**INFORMATION BULLETIN**

No. M 462-RF/27

REF. : The MN-14B Oil Pump - Modification of splineways of its driving shaft and vertical shaft mounted in the rear drive gear box.

„A” 10 : 1

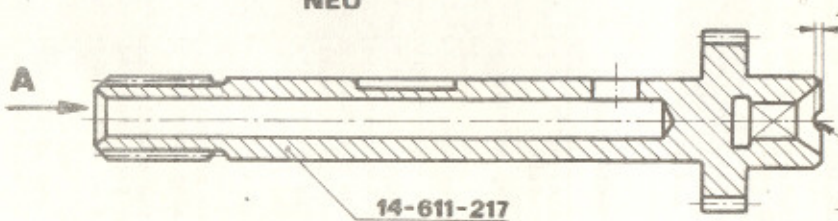
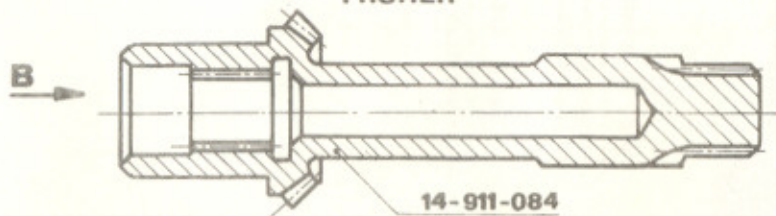
The type marking MN-14B of the oil pump has not been changed. The design modification concerns only the shape of splineways of both the shafts mentioned above. The plane spur flanks of the shaft splineways have been modified into involute flanks. This modification is distinctly illustrated in the sketches comprised herein-after and stated in the table here below:

NOTE : Both the modified shafts, Part Nos. 14-911-088 and 14-611-217 are in the face provided with a differentiating bore or a slit respectively as illustrated in the draft comprised hereinafter.
